Attachment 4. The Need to Plug and Abandon the Old LANL Test Wells, including DT-5A, DT-9 and DT-10 at TA-49, and Install New Characterization Wells

Fig. IX-U. Locations of wells, holes, and a surface water sampling station in Water Canyon north of TA-49.

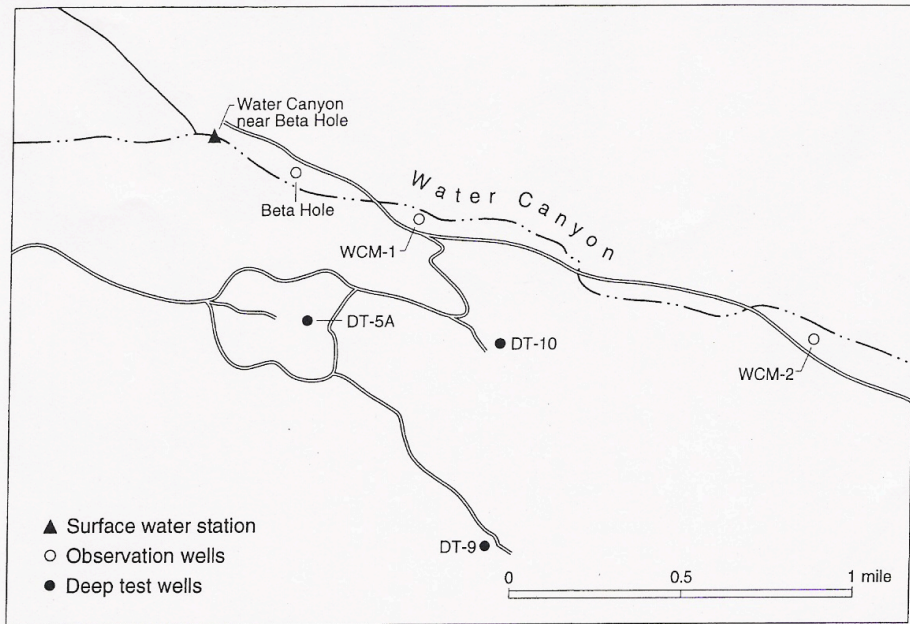
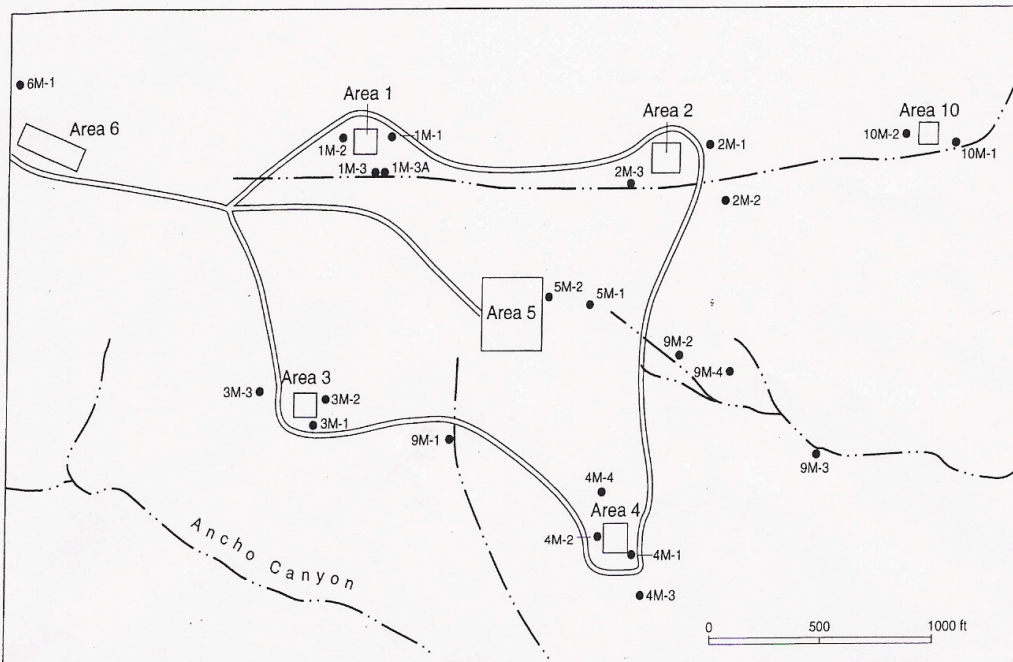
1. The wells are not at appropriate locations as shown by intercomparison of Figures IX-U and IX-V in the Purtyman report. Well DT-5A is located within Area 5 and at a distance of approximately 1000 feet from Areas 1 and 3 and approximately 900 feet from Areas 2 and 4. In addition, well DT-5A is located upgradient of the direction of groundwater travel beneath Areas 2 and 4. Well DT-9 is located approximately 3500 feet to the east of Area 2 and well DT-10 is located approximately 4500 feet to the southeast of Area 4. The regional direction of groundwater flow is shown on an enclosed map.
